CONWAY
HISTORIC DISTRICT COMMISSION
NOVEMBER

STAFF REPORT

I. Shaver Properties New Single-Family Residence - 715 Ingram Street

II. Habitat for Humanity New Single-Family Residence - 621 Walnut Street

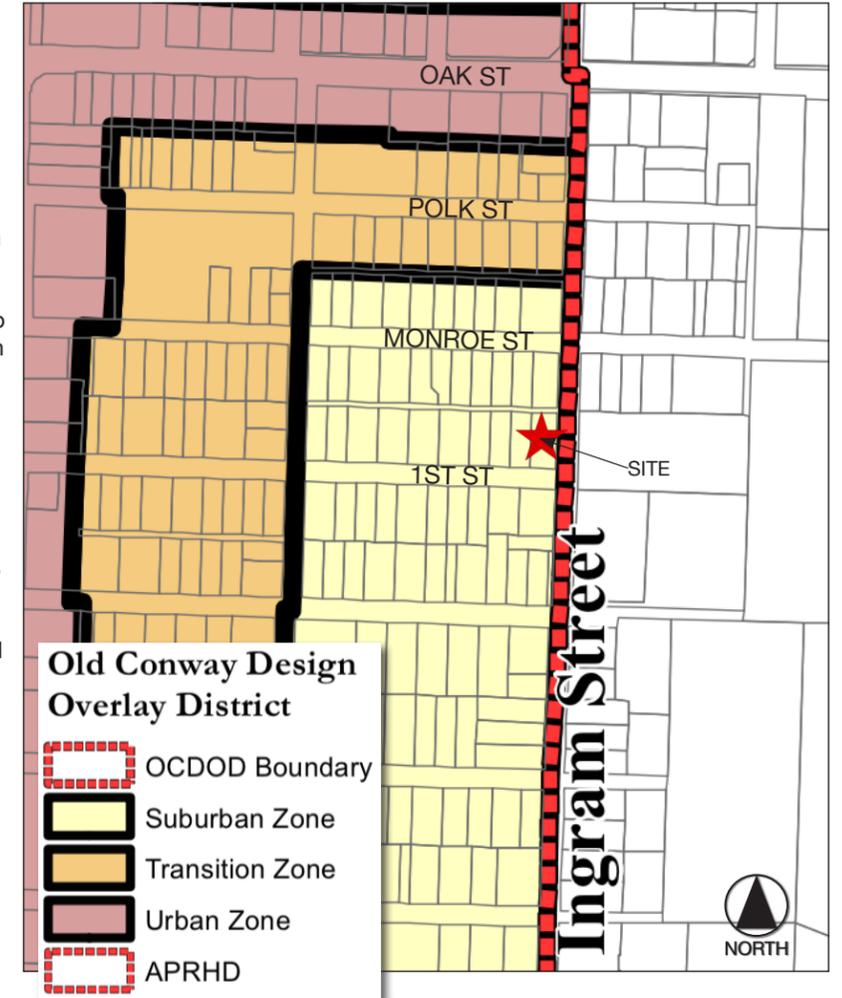
Façade, wall area, rhythm: Facades shall be compatible with surrounding historic structures in proportion of wall to opening area. Window and door openings should correspond to the rhythm and proportion on existing structures. Generally doors and windows should be proportioned in a range of 25-40% of the total surface area. The number of windows seems appropriate except for the "great room". Two additional windows should be added to the north side of this room.

1. The residence shall be constructed generally as shown on submitted plans.
2. The front setback shall be between 16 and 22 feet from the property line.
3. Any site lighting shall be inward, downward, and shrouded.
4. Additional windows shall be provided per staff recommendation. Windows shall be one over one.
5. Porch shall be a minimum of 6 feet deep. Porch columns shall be trimmed to a minimum 8" square.
6. Architectural asphalt shingles shall be used.
7. Interior floor to ceiling heights shall be 9'-0".
8. One 2" caliper pecan tree shall be planted along Ingram St.
9. HVAC equipment shall be appropriately screened and located at the rear.
10. A 4 foot wide sidewalk shall be constructed along First and

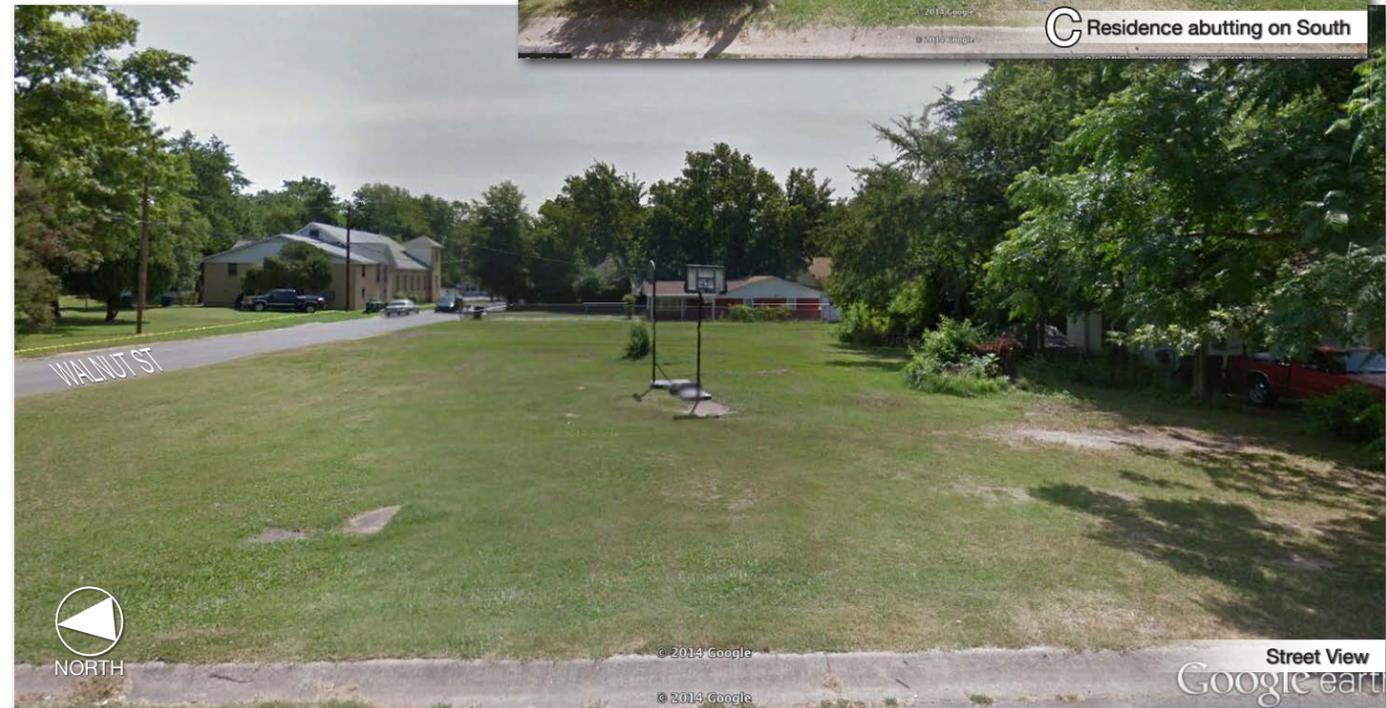
Entries, porches and porticos: A porch is proposed on the front facade. Porches should have a minimum depth of 6 feet. The porch as shown is 5 feet deep gable. This needs to be increased to at least 6 feet. The porch as shown is also too low. The gable should be raised so that the tops of the door and windows are clearly visible. The gable design as shown is not typical.

Doors and windows. The living room windows could also be taller to match other windows. To avoid "fake" window light dividers, one over one sashes should be used. Additional windows should be added to the north east and west facades.

1. The residence shall be constructed generally as shown on submitted plans.
2. The front setback shall be between 19 and 26 feet from the property line.
3. Any site lighting shall be inward, downward, and shrouded.
4. Living Room windows shall be taller to match other windows. Windows shall be one over one.
5. Additional windows shall be provided per staff recommendation.
6. Porch shall be minimum of 6 feet deep. Porch columns must be trimmed to a minimum 8" square. Porch gable and trim height shall be raised as shown in staff sketch.
7. Interior floor to ceiling heights shall be 9'-0".
8. HVAC equipment shall be appropriately screened and located at the rear.
9. A 4 foot wide sidewalk shall be constructed along Factory and Ingram Streets.
10. Driveway and parking area?

Staff Sketch

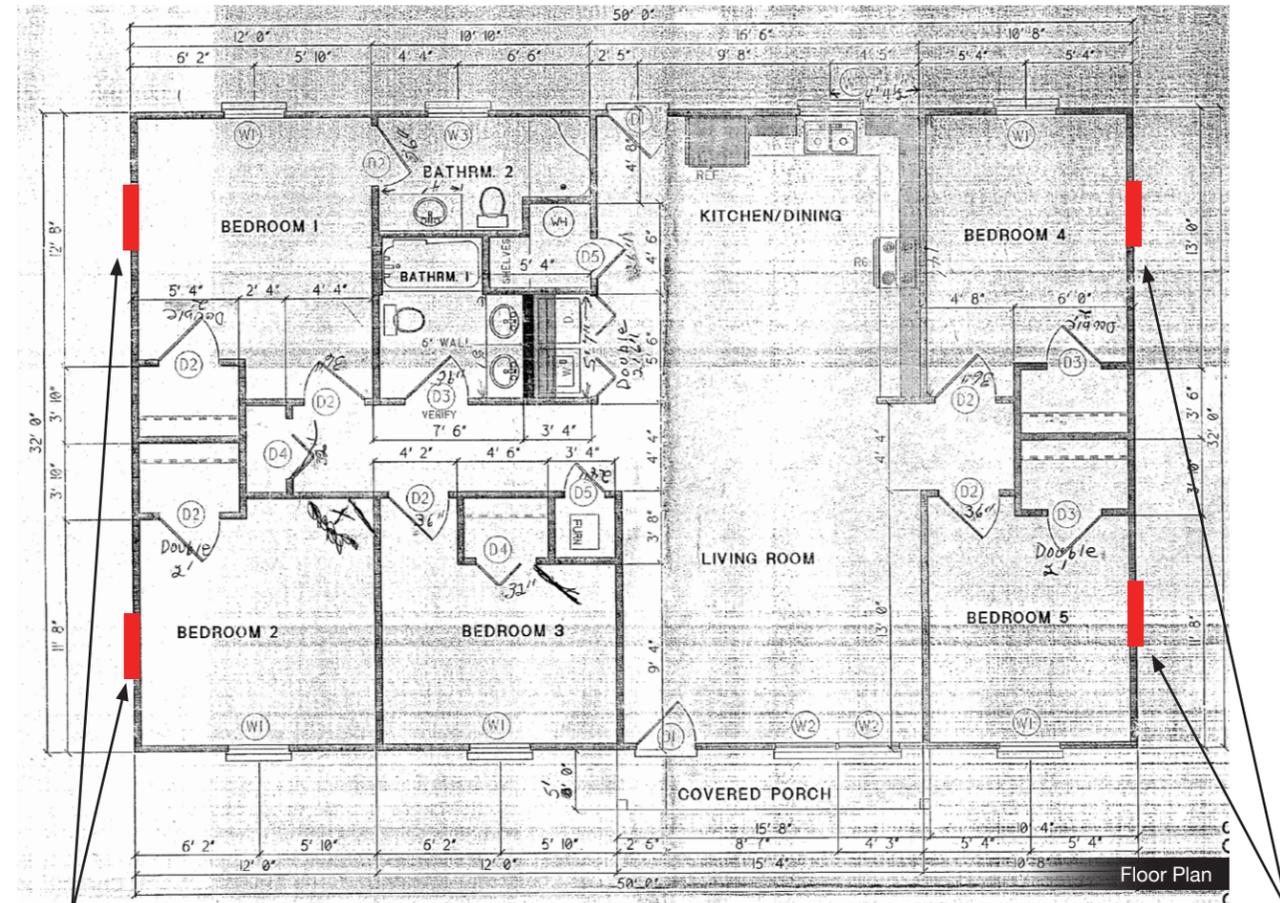
Additional windows shown per recommendation no. 5.

Habitat for Humanity Submitted Elevations

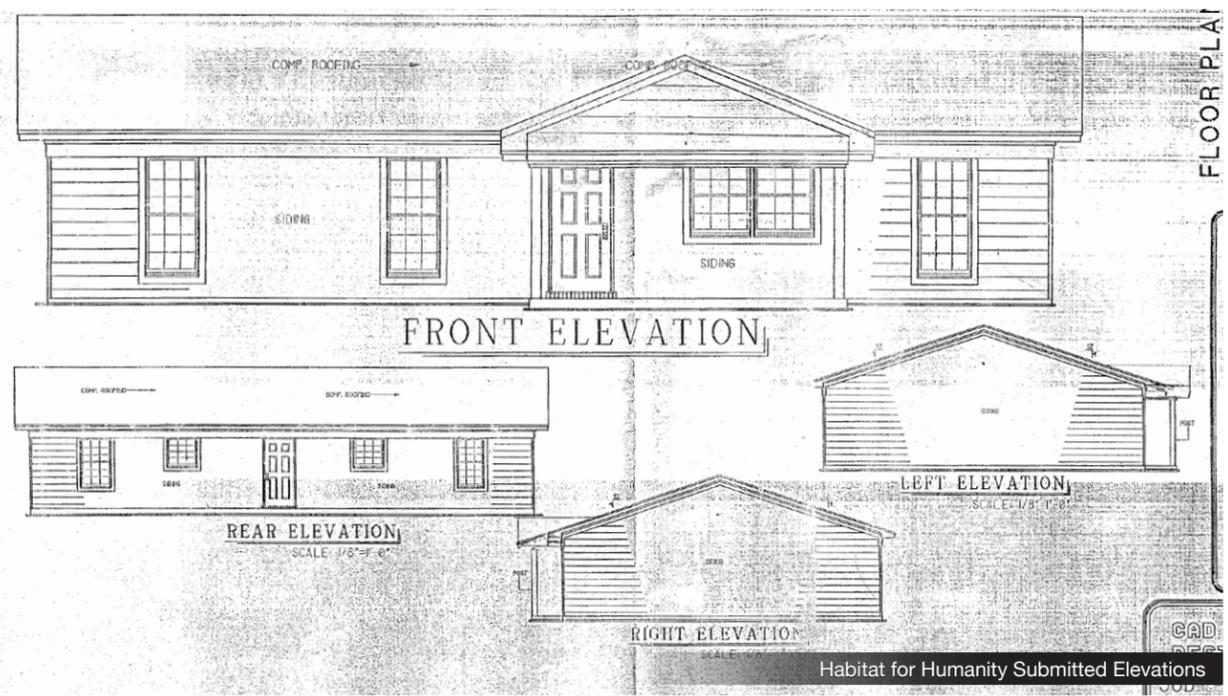
Façade, wall area, rhythm: Facades shall be compatible with surrounding historic structures in proportion of wall to opening area. Window and door openings should correspond to the rhythm and proportion on existing structures. Generally doors and windows should be proportioned in a range of 25-40% of the total surface area. Additional windows should be added to the north east and west facades.
